Tabernacle Phase 5
CR 1-2022

Martha's Vineyard Commission
April 14, 2022

Tabernacle Phase 5

Concurrence review

Sheet
5

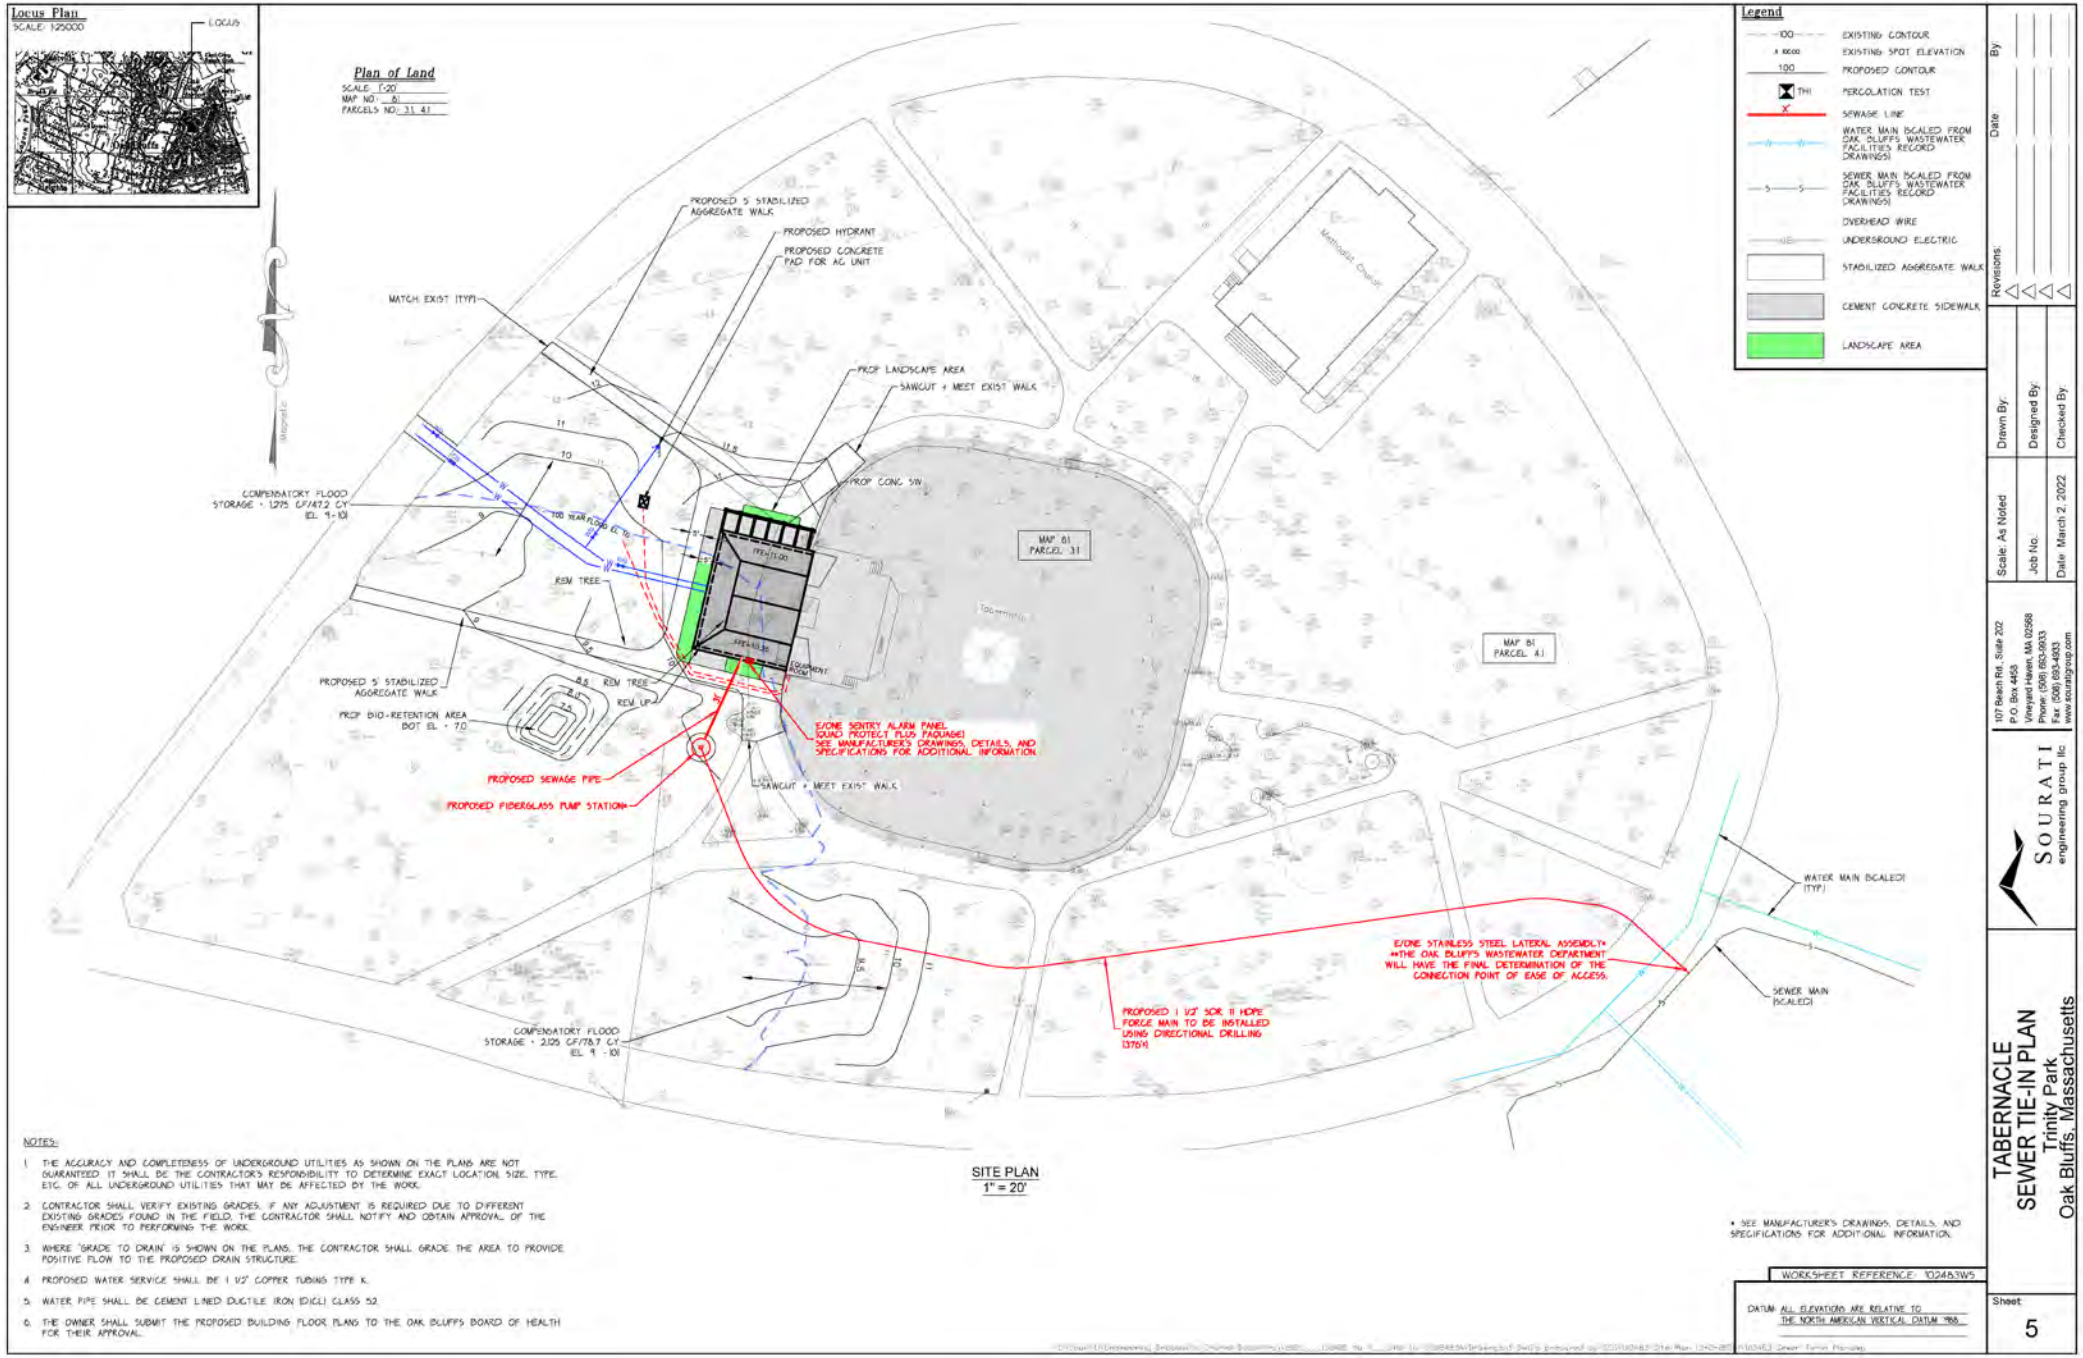
- The MVCMA is connected to the town sewer, but the Tabernacle currently is not.
- Proposal includes a new sewer line and pump, but final approval from the town to connect to the system is still pending.
- MVCMA currently provides up to six portable toilets, and will continue to do so until the new ones are connected.
- The new wastewater flow would at least partly replace existing flow from other restrooms in the area.

1 FP200 NEW ADDITION PLAN - FIRE PROTECTION
1/4" = 1'-0"

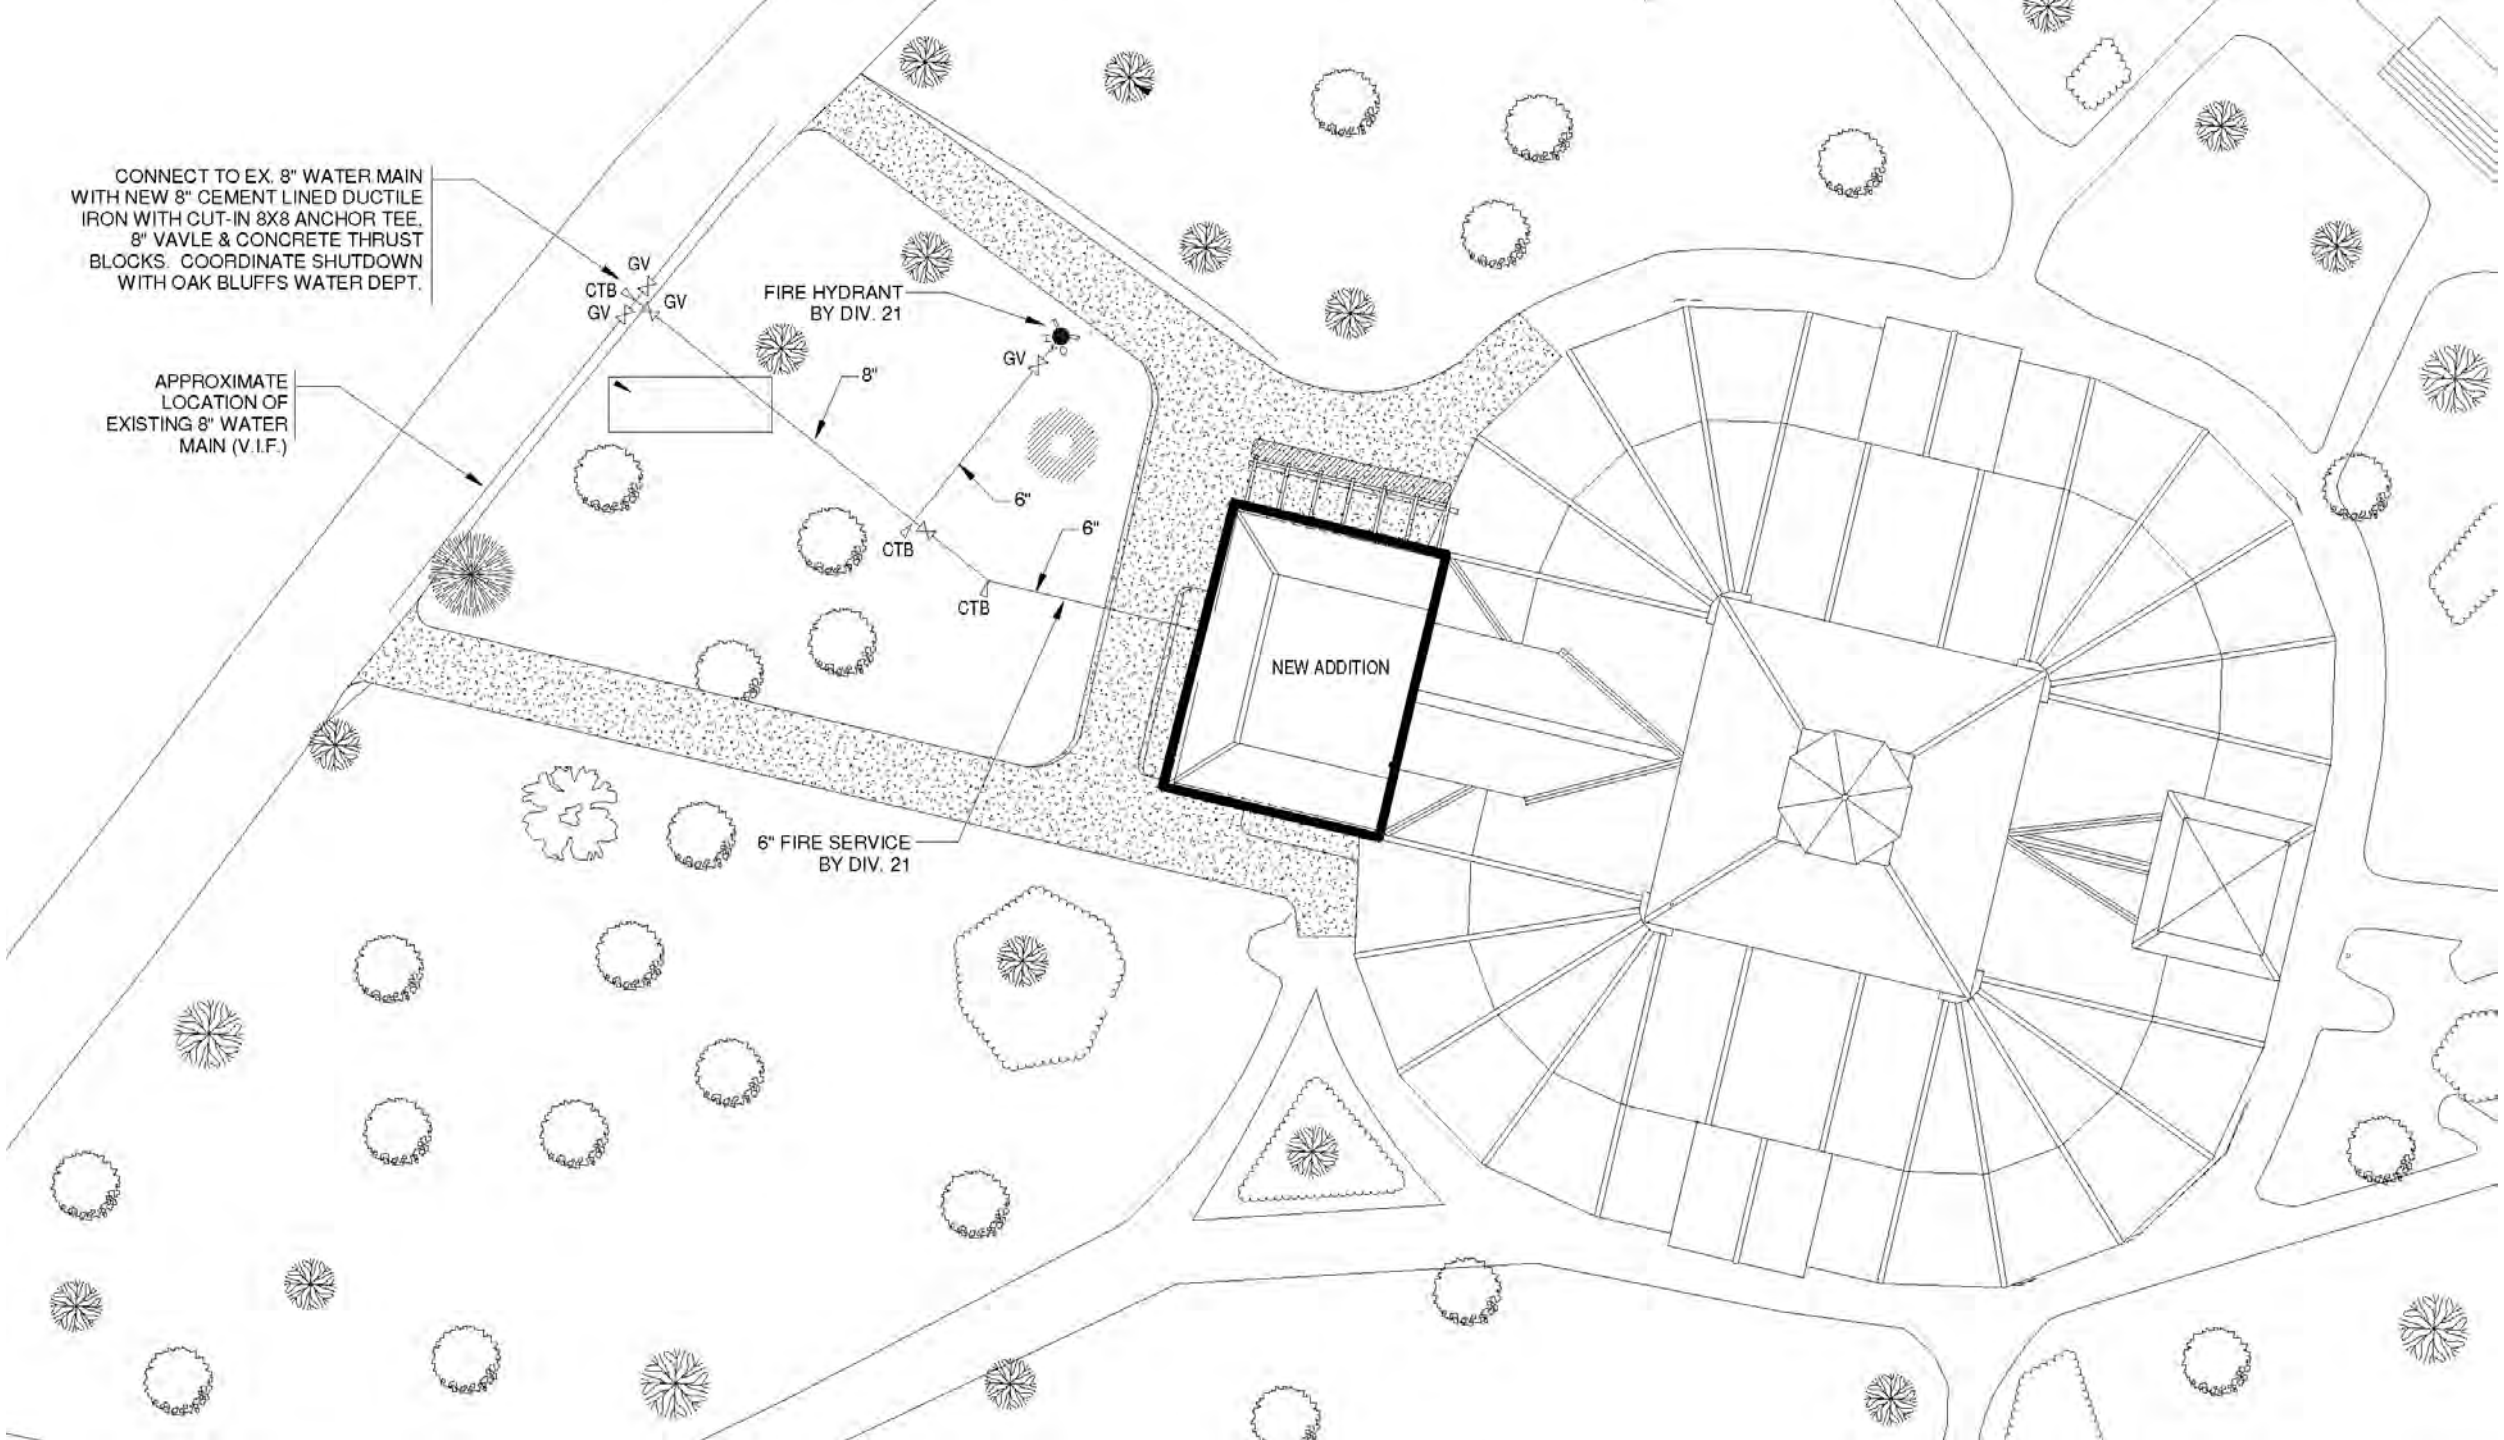
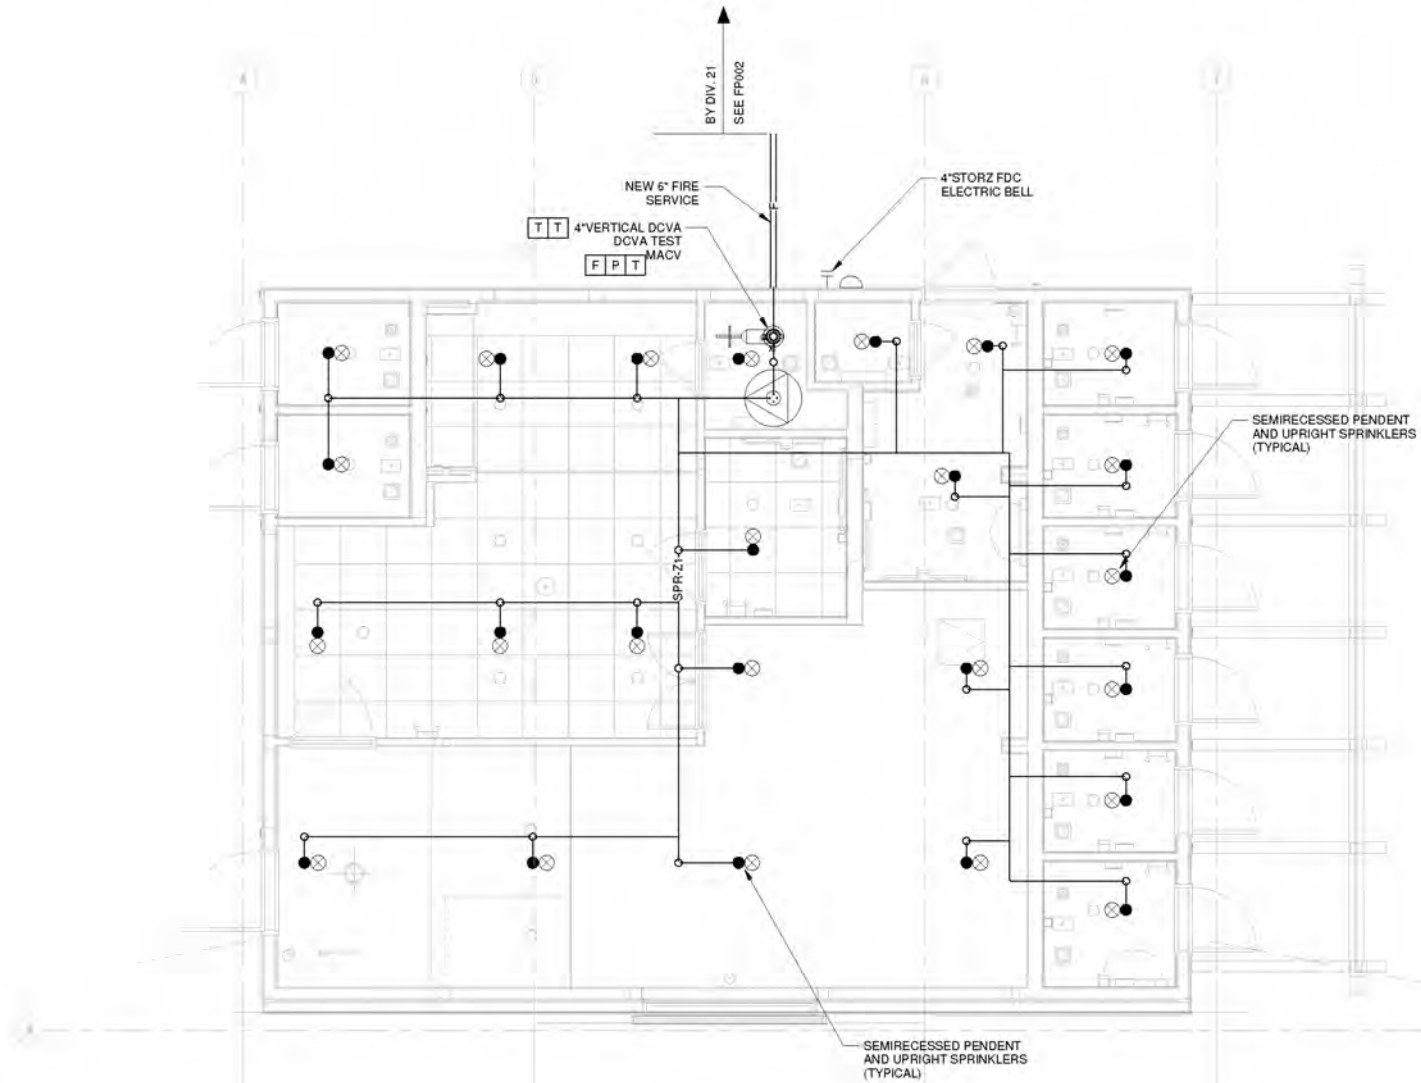
- Proposal includes sprinklers in the new addition, as well as a fire alarm system throughout the structure, as required by the MA Automatic Sprinkler Appeals Board.
- The existing roof contains asbestos, but is not considered a current health concern since the structure is open to the air.
- The addition will improve handicapped access to the stage.

FLOODPLAIN PLAN
1" = 20'

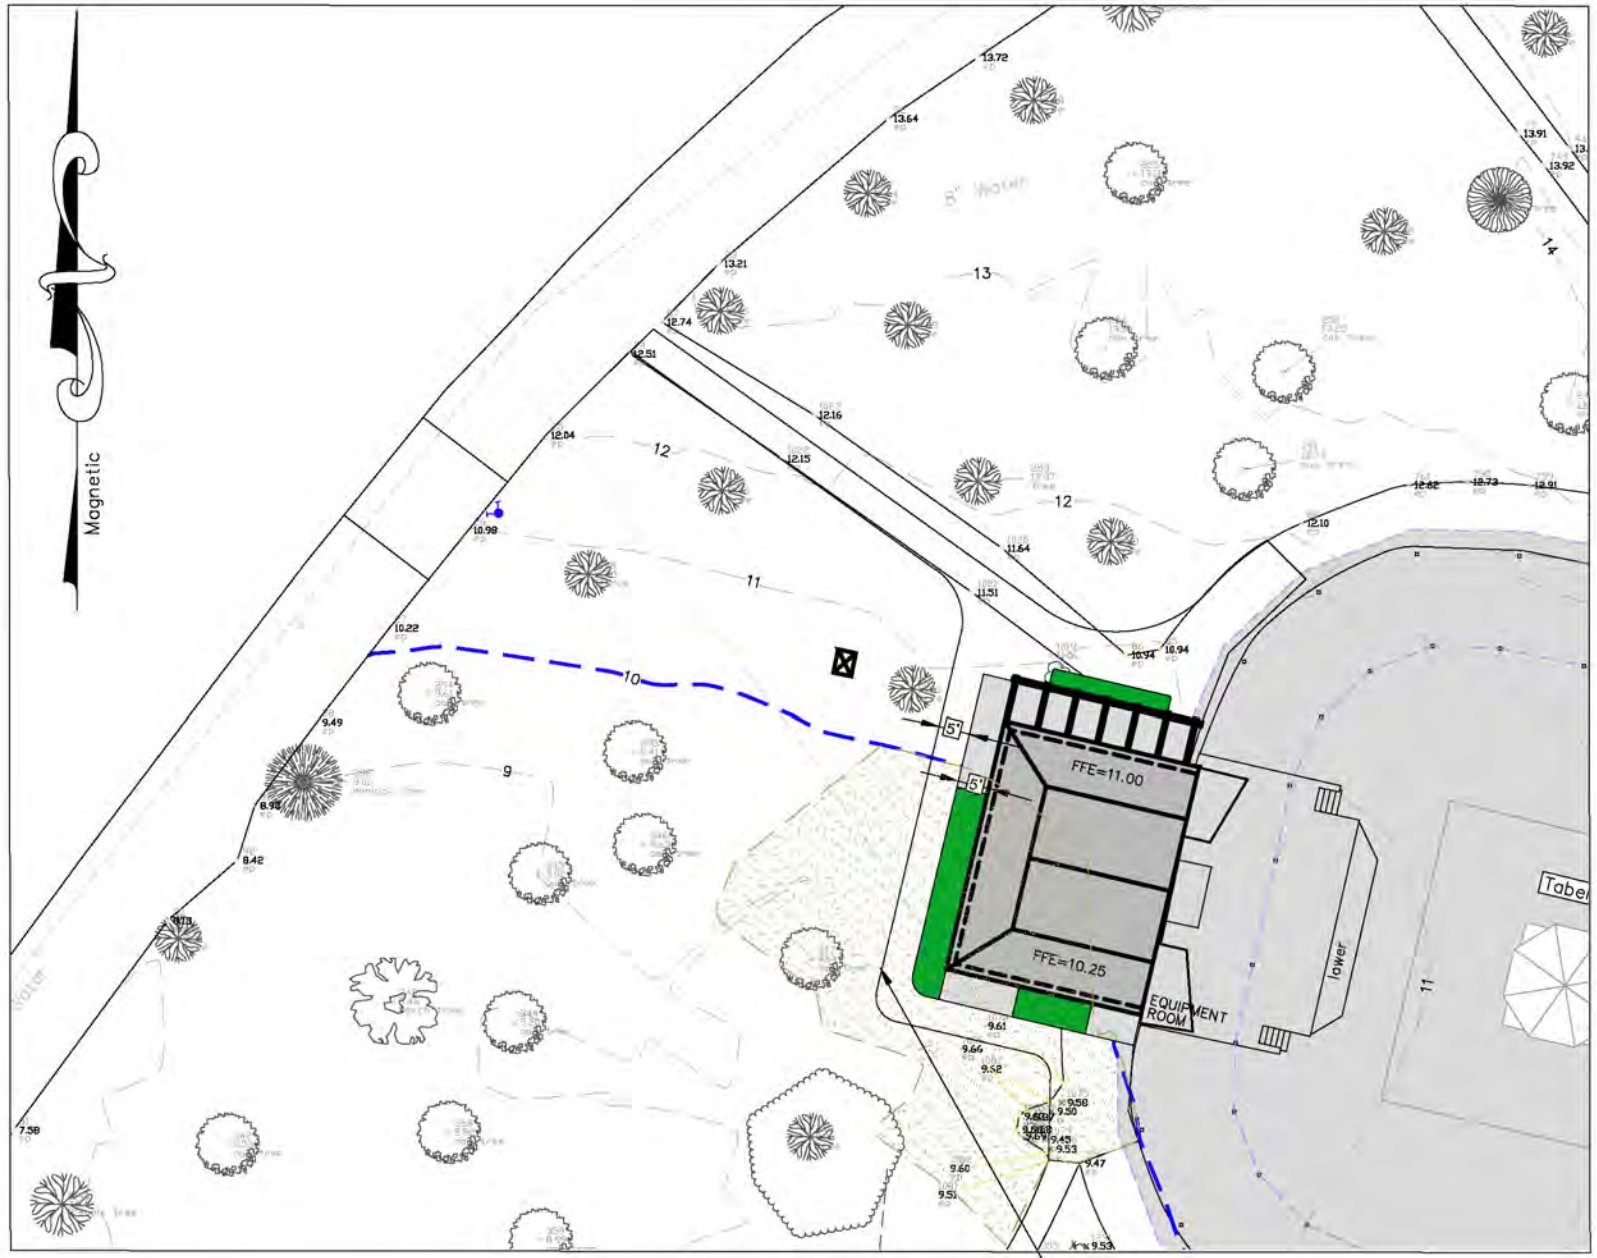
- A portion of the addition is within the FEMA AE flood hazard area and the Oak Bluffs Floodplain Overlay District.
- The addition and utilities will require some regrading, including within the floodplain.
- The volume floodplain impact is about 3,389 ft^3 (plans say 2,940 ft^3) and a bioretention area is proposed onsite as compensatory storage.
